### ContiTech

## Installation Tip for WPS3025 Coolant Pump for BMW 135i, 335i, 535i, 640, 740i from model year 2007

**Fig. 1**

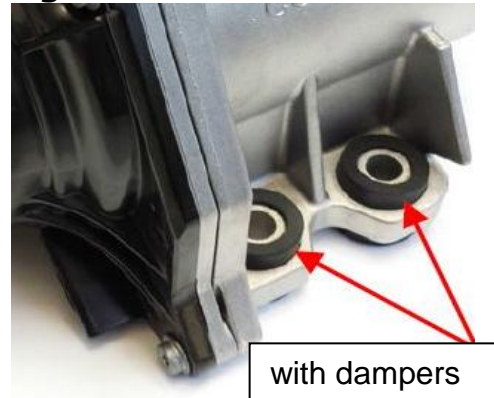
The electric coolant pump which has been removed may have prefitted dampers at the three screw-fastening points (Fig. 1). The new WPS3025 coolant pump does not have these. The old fastening bolts are not suitable for reuse.

The vehicle manufacturer has changed the coolant pump over to this new design without dampers (Fig. 2).

The aluminum bolts which have been removed (M8x36) must not be reused, but must be replaced with shorter steel bolts (M8x26).

Please use the MS50 mounting set (Fig. 3) which is available separately.
